## Product Change Notification - SYST-03GEE0632

**Notification subject:** ERRATA - dsPIC33EPXXX(GP/MC/MU)806/810/814 and PIC24EPXXX(GP/GU)810/814 Errata Errata Document Revision

## dsPIC33EPXXX(GP/MC/MU)806/810/814 and PIC24EPXXX(GP/GU)810/814 Family Silicon Errata and Data Sheet Clarification

**FIGURE 16-2: HIGH-SPEED PWM MODULE REGISTER INTERCONNECTION DIAGRAM**

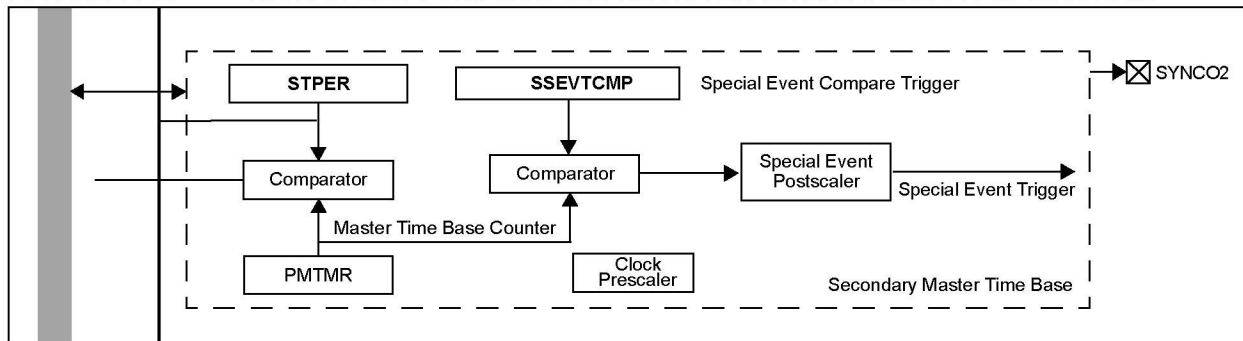
**16. Module: High-Speed PWM Module (dsPIC33EPXXX(MC/MU)8XX Devices Only)**

In **Figure 16-2: High-Speed PWM Module Register Interconnection Diagram**, the Secondary Master Time Base section has been updated. The updated text is shown in **bold** in [Figure 16-2](#) below.
